**SUSQUEHANNA STEAM ELECTRIC STATION
REVISION TO PLA – 5341
PROPOSED AMENDMENT NO. 240 TO LICENSE
NFP-14 AND PROPOSED AMENDMENT NO. 205 TO
LICENSE NFP-22: CHANGES TO REACTOR PRESSURE VESSEL
PRESSURE-TEMPERATURE (P-T) LIMITS AND REQUEST FOR
EXEMPTION FROM THE REQUIREMENTS
OF 10CFR50 SECTION 50.60(a).
PLA-5345**

**SUSQUEHANNA STEAM ELECTRIC STATION
PROPOSED AMENDMENT NO. 240 TO LICENSE
NFP-14 AND PROPOSED AMENDMENT NO. 205 TO
LICENSE NFP-22: CHANGES TO REACTOR PRESSURE VESSEL
PRESSURE-TEMPERATURE (P-T) LIMITS AND REQUEST FOR
EXEMPTION FROM THE REQUIREMENTS
OF 10CFR50 SECTION 50.60(a)
PLA-5341**

The purpose of this letter is to propose revisions to the Susquehanna Steam Electric Station Units 1 and 2 Technical Specifications Figure 3.4.10-1 "Reactor Vessel Pressure vs. Minimum Vessel Temperature", and the associated TS Surveillance Requirements SR 3.4.10.1 and 3.4.10.2. In addition, changes are also made to TS Bases B3.4.10 and B3.10.1.

Figure 3.4.10-1 (page 1 of 1)

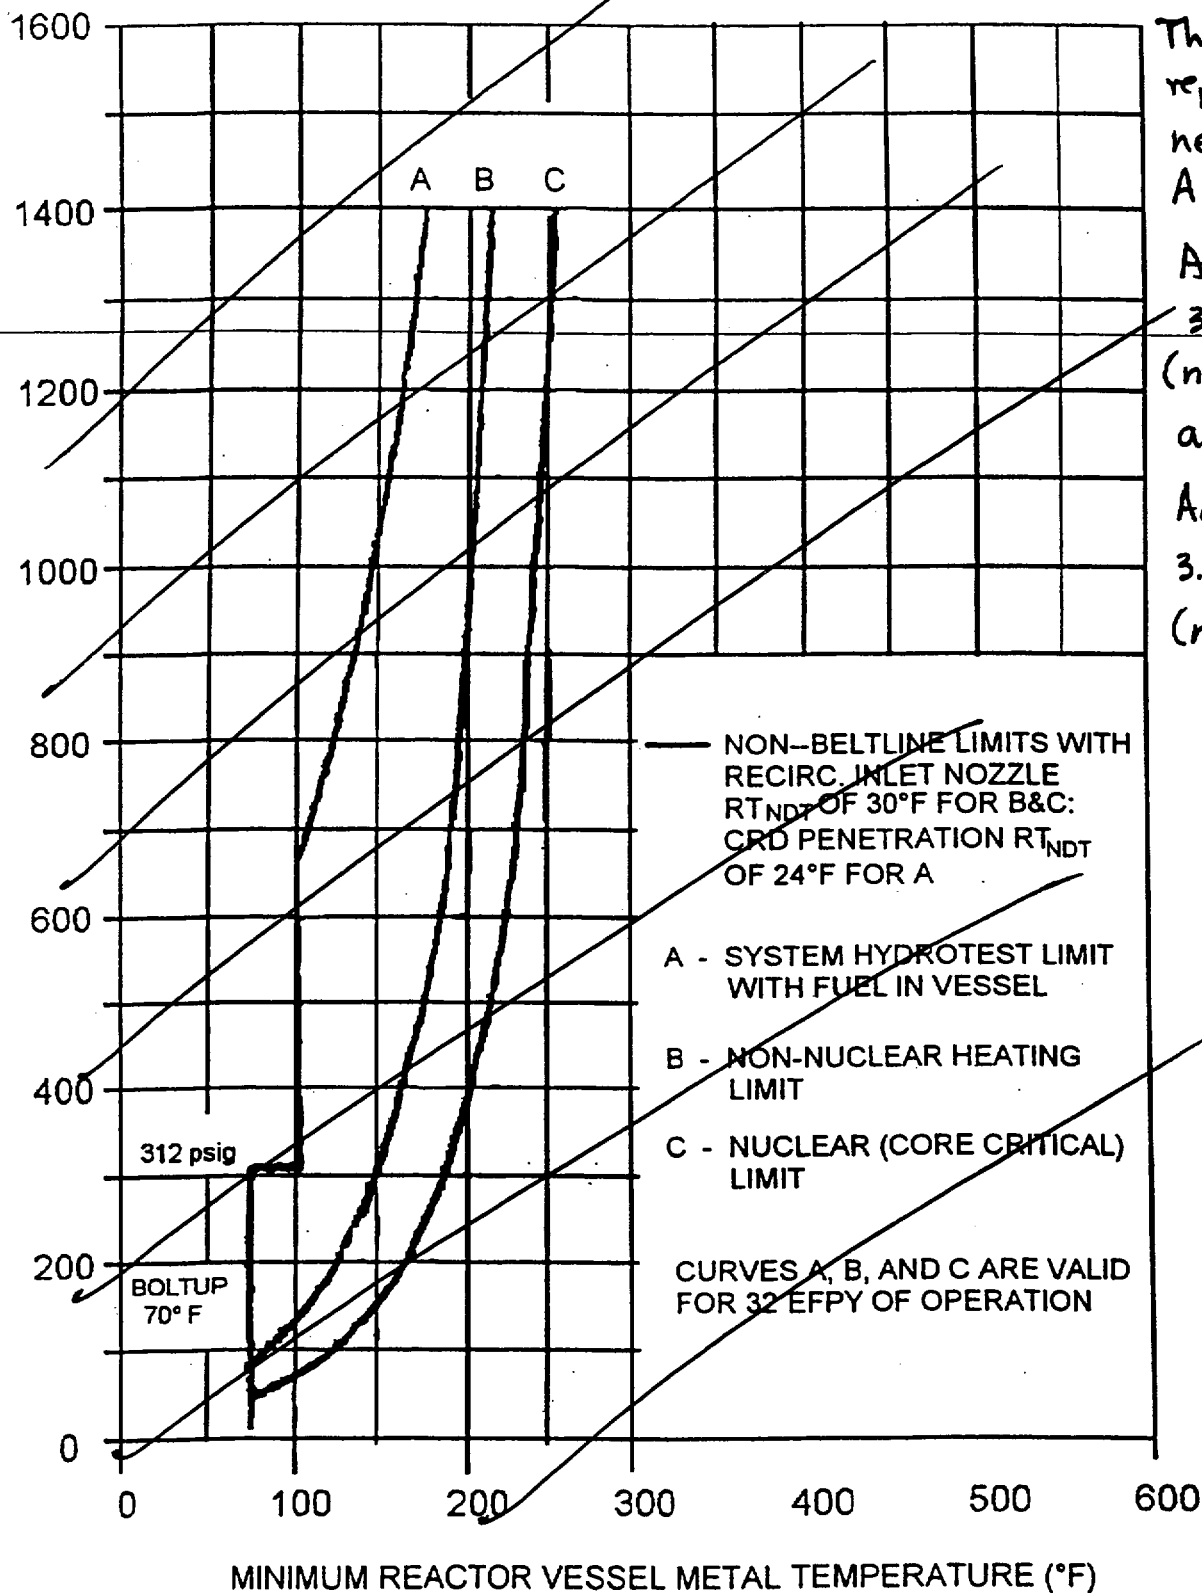
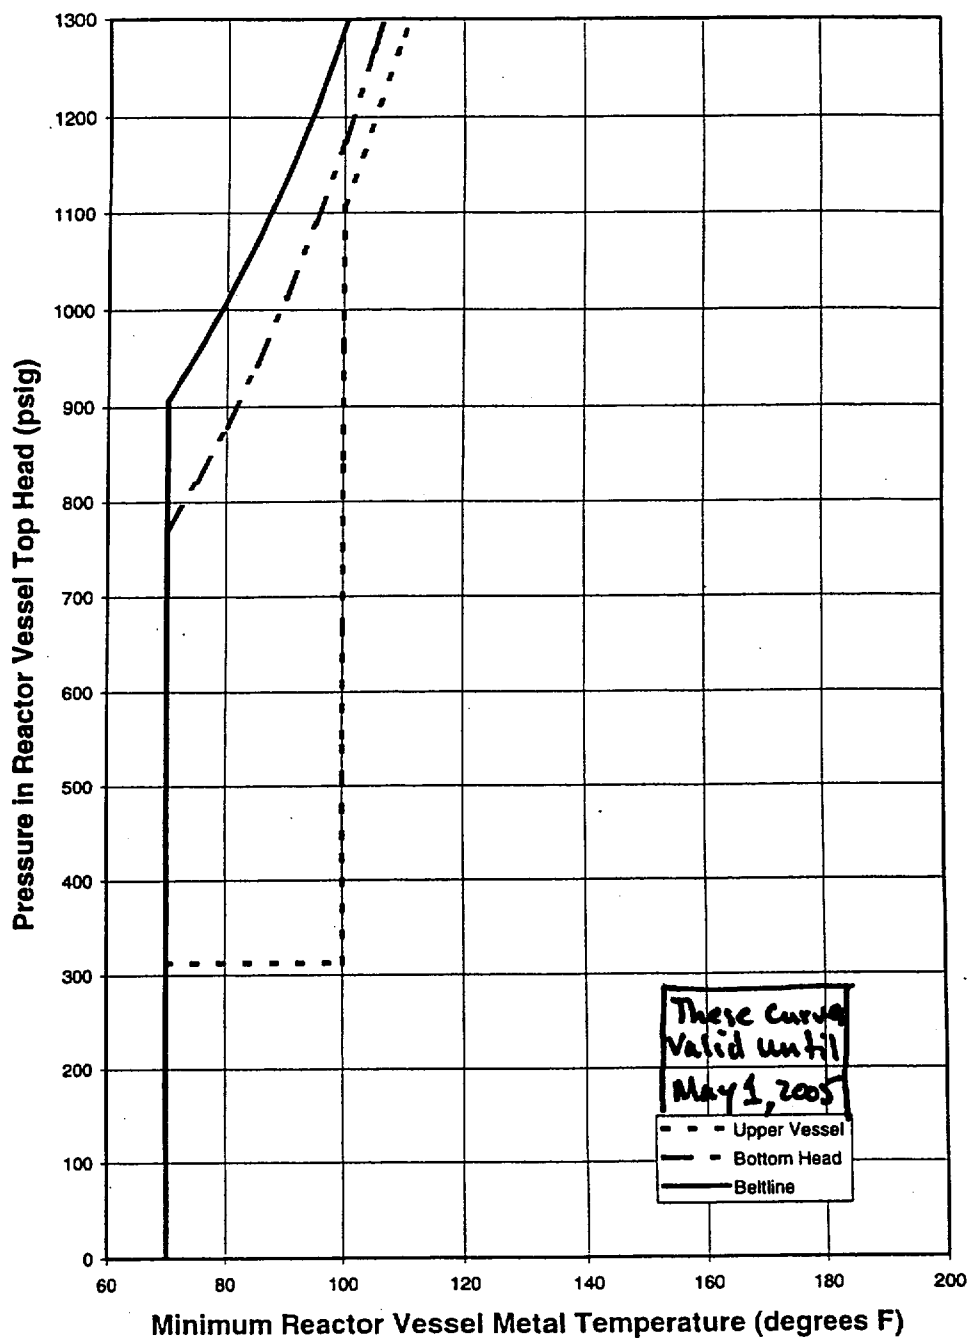
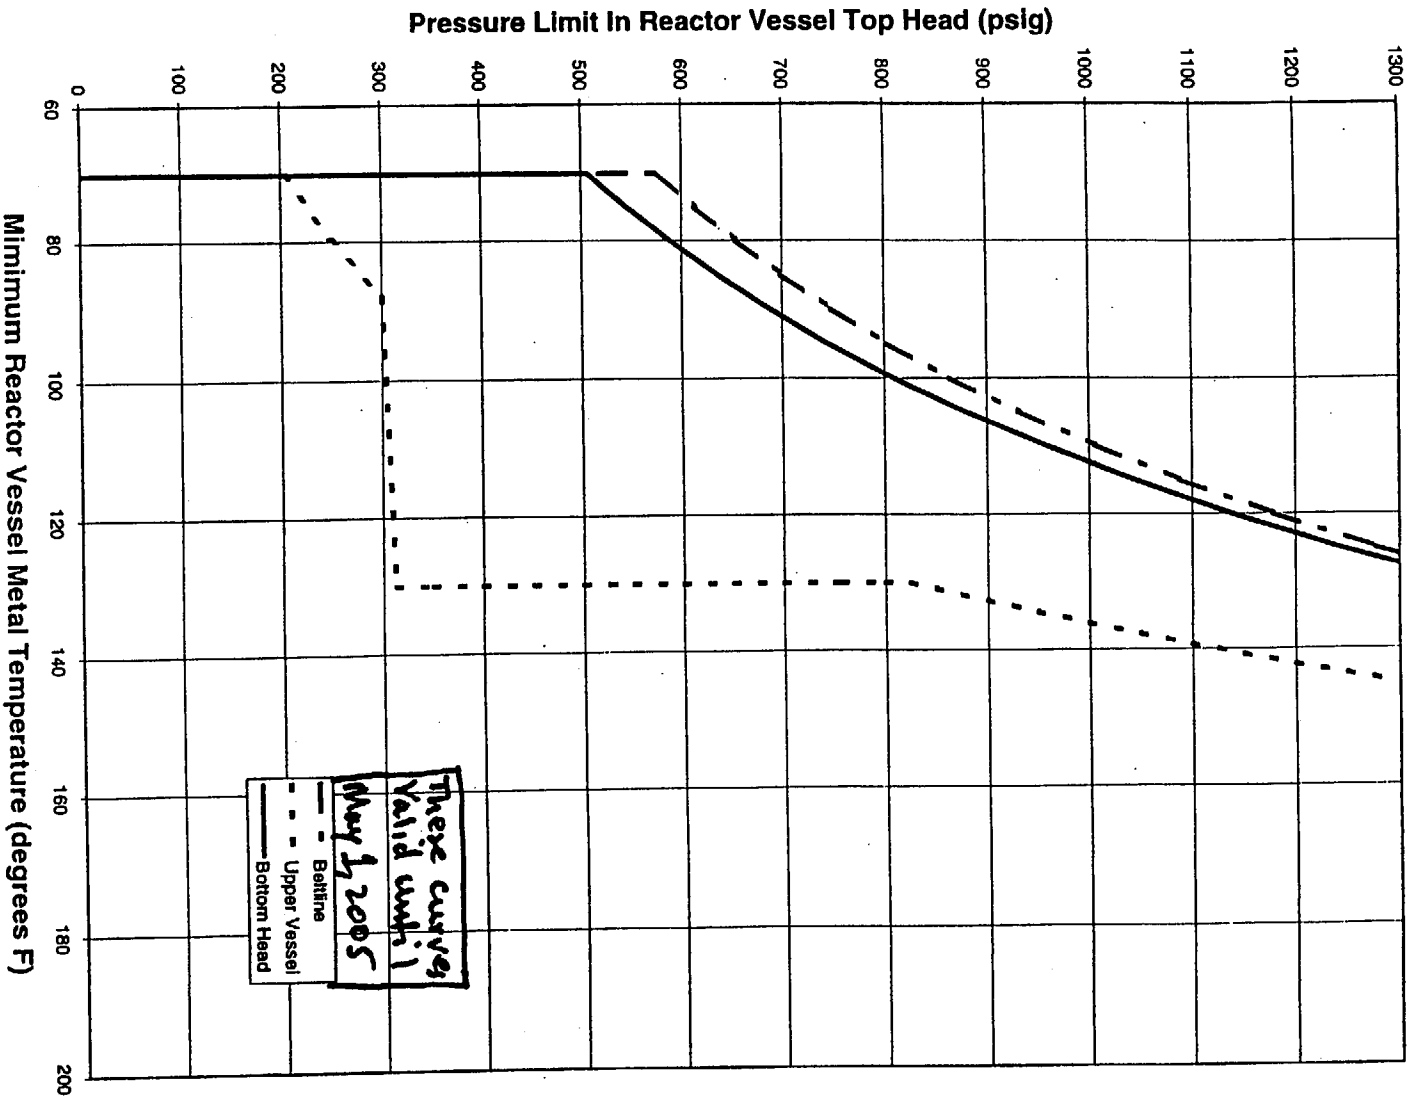
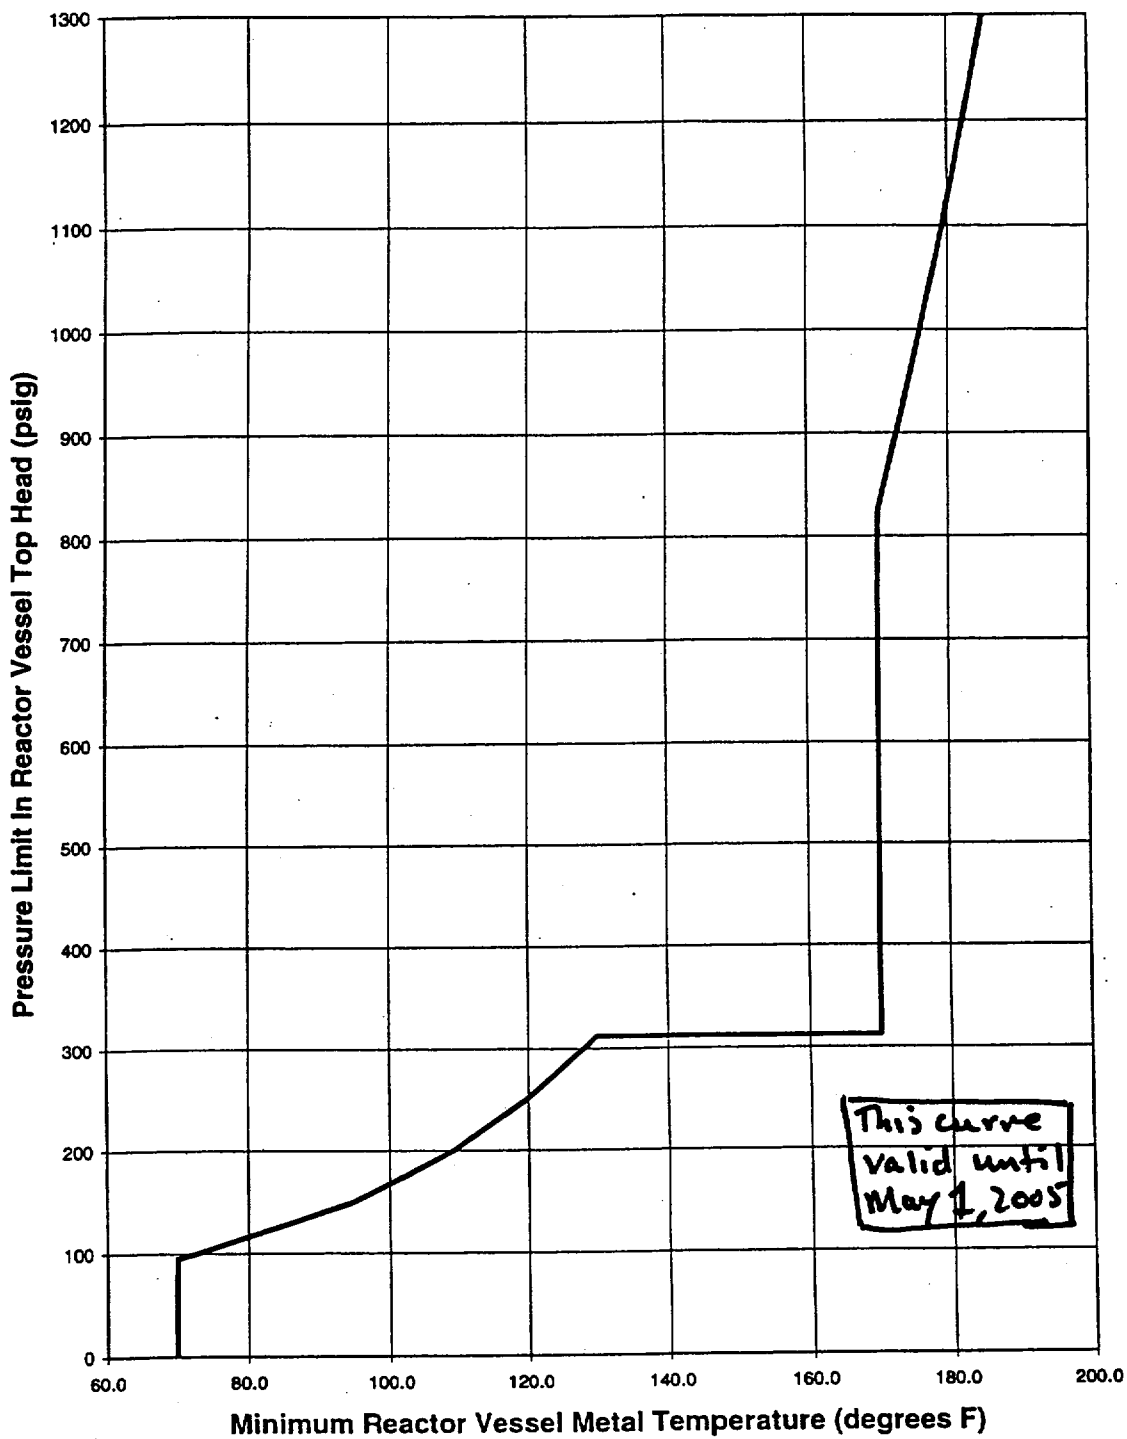
This figure
replaced with
new PT Curve
A,

~~Figure 2~~ Figure 3.4.10-1
Pressure Test P-T Curve (Curve A) ~~for Unit 2~~

~~Figure 3.4.10-2~~ Figure 3.4.10-2
Core Not Critical Curve (Curve B) ~~Figure 3.4.10-2~~

~~Figure 6~~ Figure 3.4.10-3
Core Critical Curve (Curve C) for ~~Unit 2~~

The proposed changes are to the Units 1 and 2 Technical Specification Figure 3.4.10-1, which shows the P-T limit curves for inservice leakage and hydrostatic testing, non-nuclear heatup and cooldown, and criticality, respectively.

The number of curves has been expanded from one to three to separately address beltline, bottom head, and non-beltline regions. In addition to the curve changes, editorial changes to the Limiting Condition for Operation and Surveillance Requirements of Technical Specification 3.4.10 are also proposed.
